HISTORIC AND DESIGN REVIEW COMMISSION

HDRC CASE NO: 2019-259
ADDRESS: 119 BUFORD
LEGAL DESCRIPTION: NCB 1369 BLK 6 LOT S 81.3 FT OF 4
ZONING: R-4, H
CITY COUNCIL DIST.: 2
DISTRICT: Dignowity Hill Historic District
APPLICANT: Mark Granato/Granato Custom Homes
OWNER: Mark Granato/DAL HOLDINGS LLC
TYPE OF WORK: Construction of a 1 story, single family residential structure
APPLICATION RECEIVED: April 30, 2019
60-DAY REVIEW: June 29, 2019
CASE MANAGER: Edward Hall
REQUEST:

The applicant is requesting a Certificate of Appropriateness for approval to construct a one story, single family residential structure on the vacant lot at 119 Buford, located within the Dignowity Hill Historic District.

Right Side Elevation

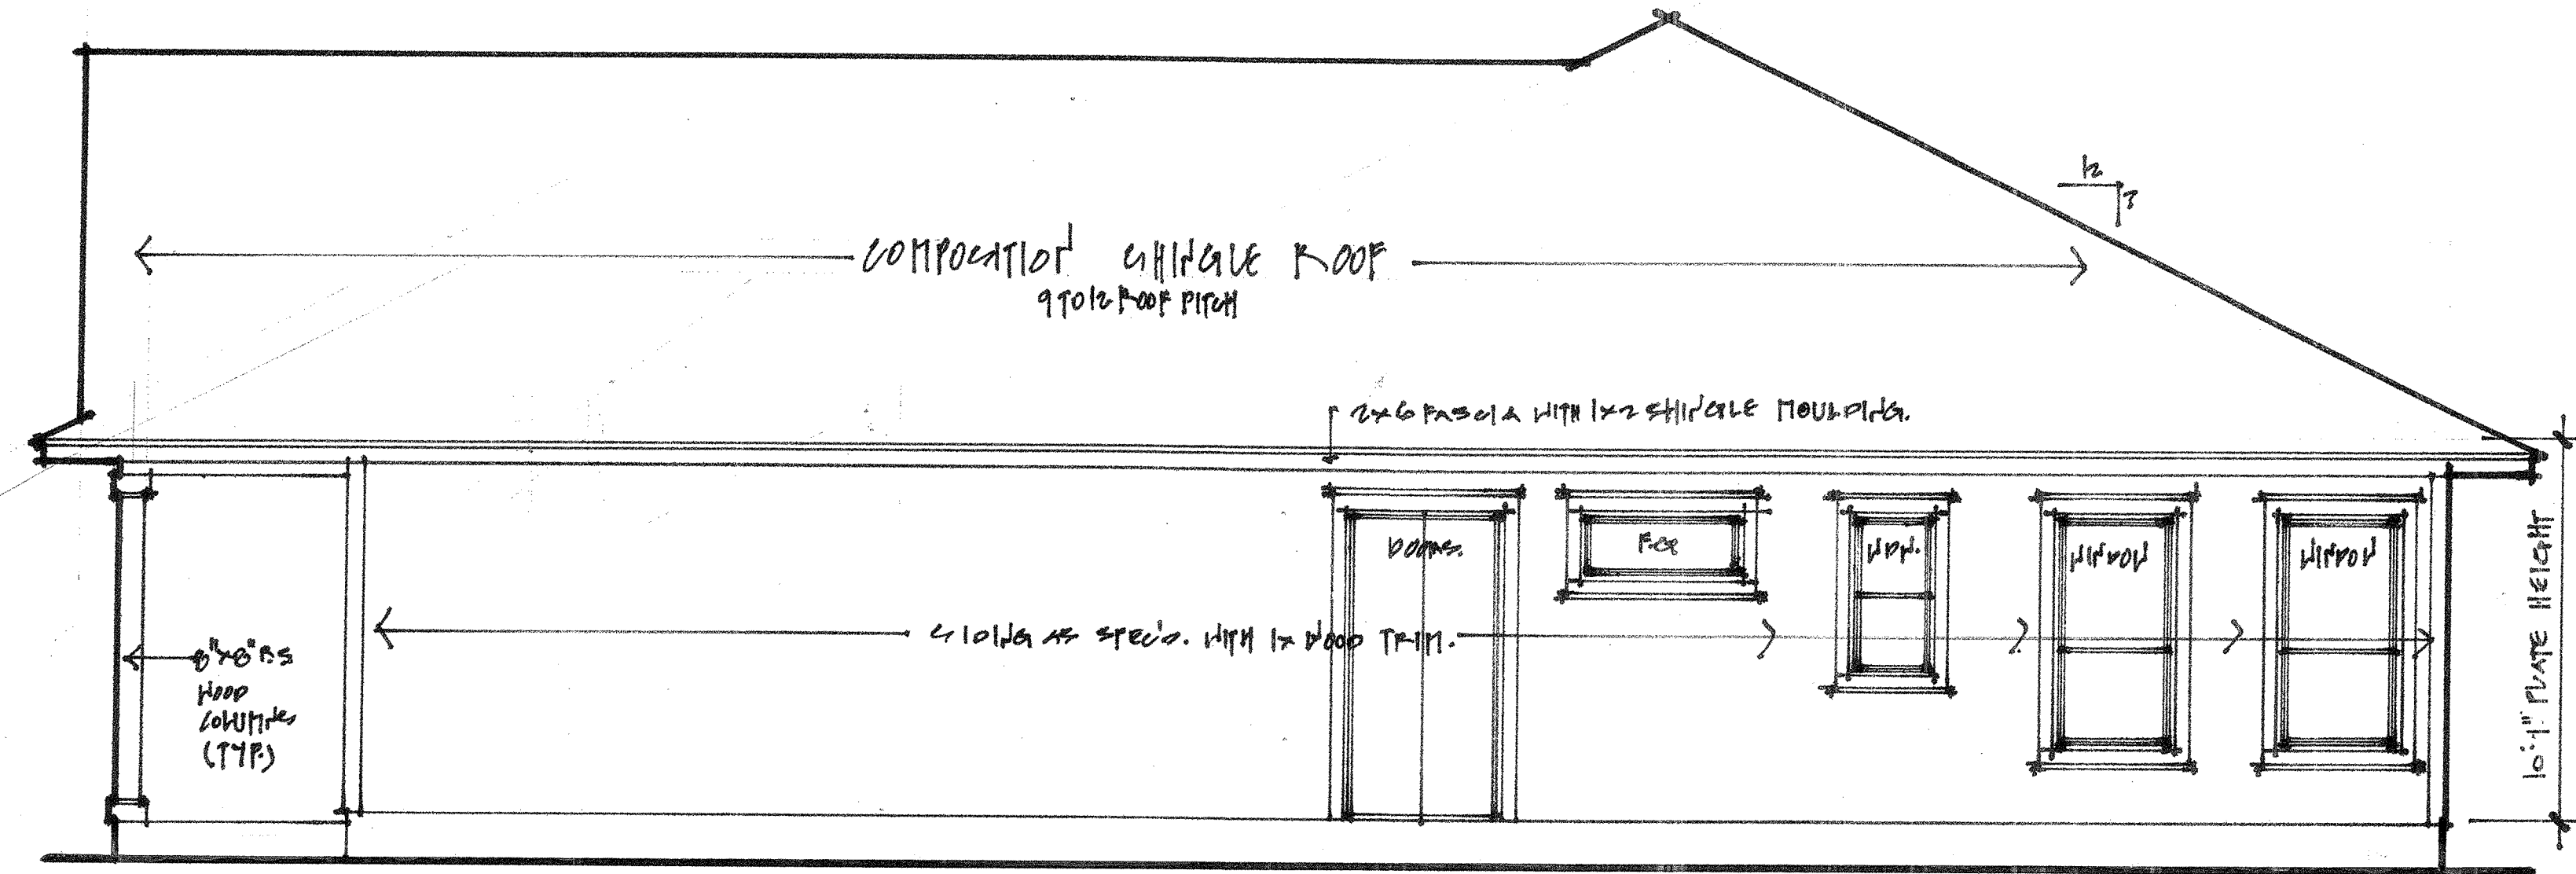
- h. ARCHITECTURAL DETAILS – The applicant has proposed an overall form and massing that are comparable to that found on Buford Alley and predominantly throughout the Dignowity Hill Historic District. Staff finds that additional fenestration along the east facade, particularly in the living room and on the west façade in the dining area should be added to separate wall planes that are currently blank.

- i. That the applicant confirm that the proposed setback is greater than those of the neighboring historic structures.
- ii. That the applicant incorporate additional fenestration on the east façade.

Front Elevation

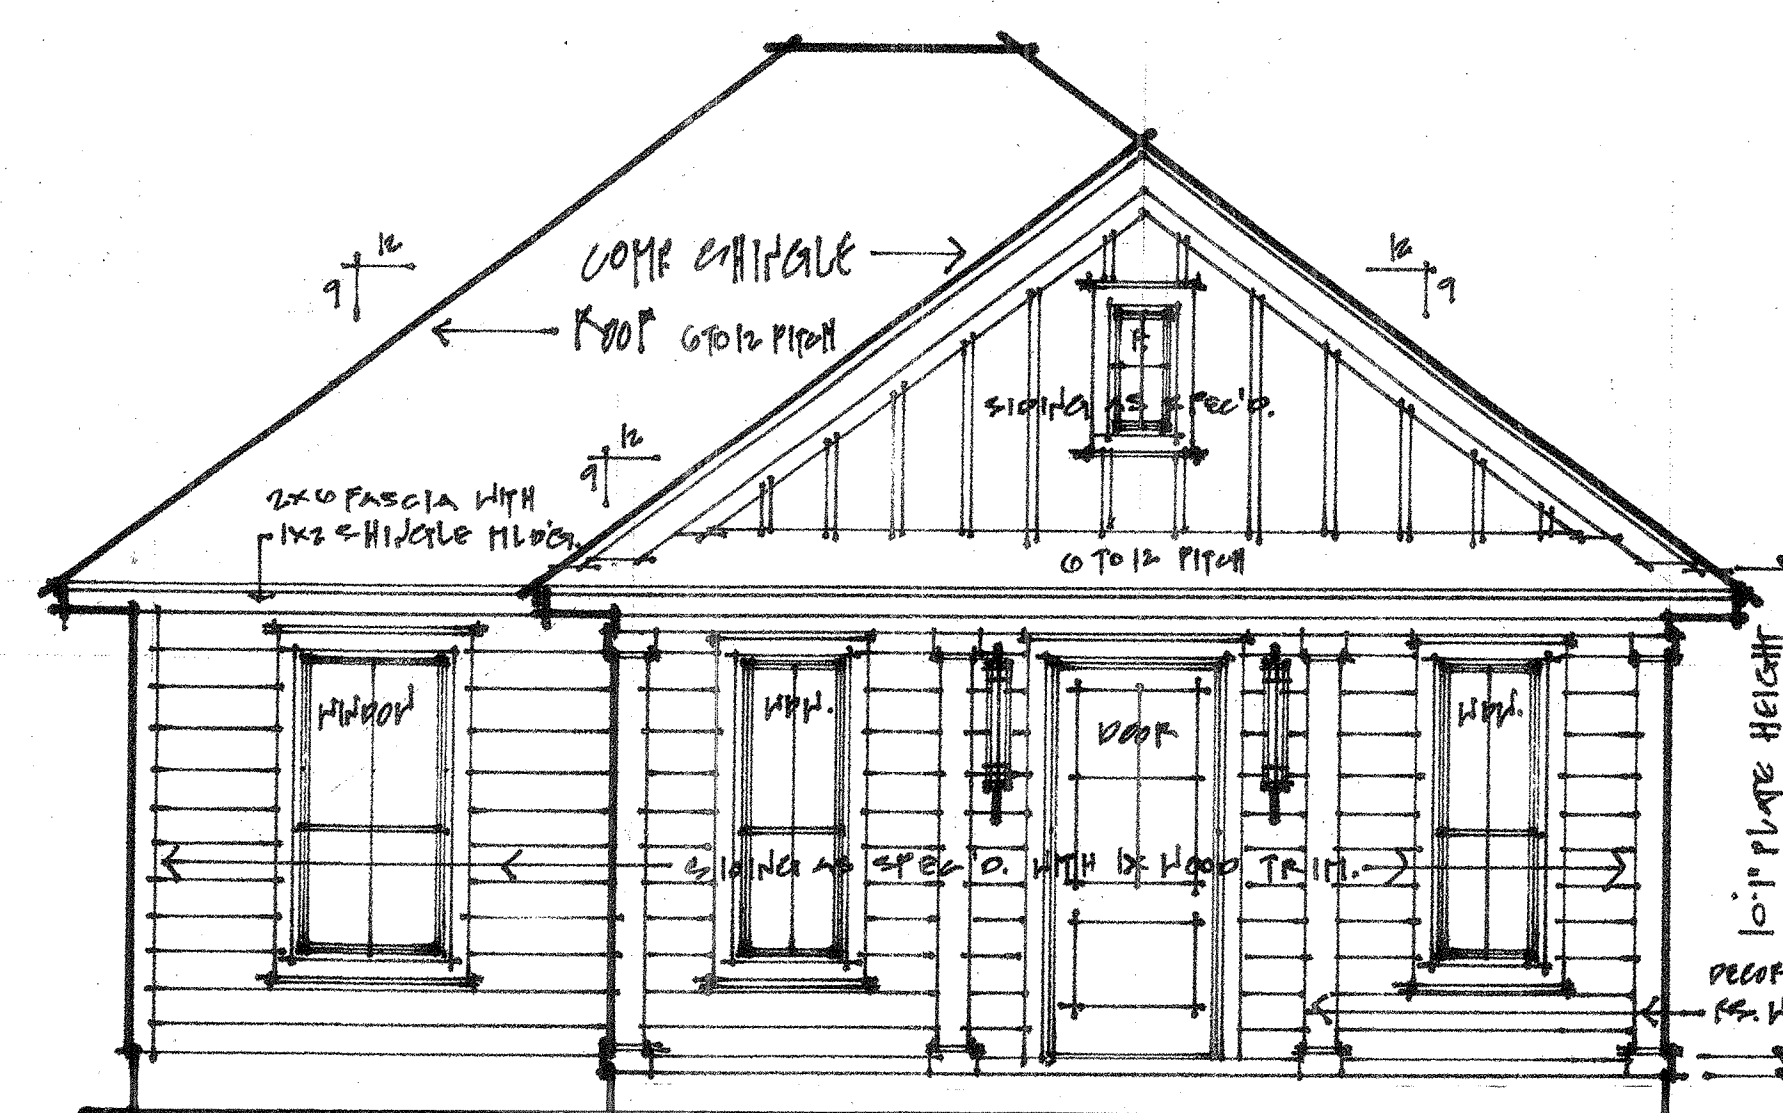
- g. ROOF FORM – The applicant has proposed for the new construction to feature both a front facing, gabled porch roof and a primary roof structure that is a hipped roof. Generally, the proposed roof form is appropriate.

- i. **MATERIALS** –The applicant has proposed materials that include Jeldwen aluminum clad wood windows, Hardie siding and an asphalt shingle roof. Generally, staff finds the proposed materials to be appropriate; however, composite, horizontal siding should feature an exposed profile of four inches and a thickness of approximately $\frac{3}{4}$ ". A composite siding should feature smooth finishes and mitered corners. Window and door trim should feature thicknesses that are appropriate for the thickness of the siding; at least 1 inch, and should be installed abutting the siding.

- iv. That horizontal siding feature an exposed profile of four inches and a thickness of approximately $\frac{3}{4}$ ". A composite siding should feature smooth finishes and mitered corners. Window and door trim should feature thicknesses that are appropriate for the thickness of the siding; at least 1 inch, and should be installed abutting the siding.
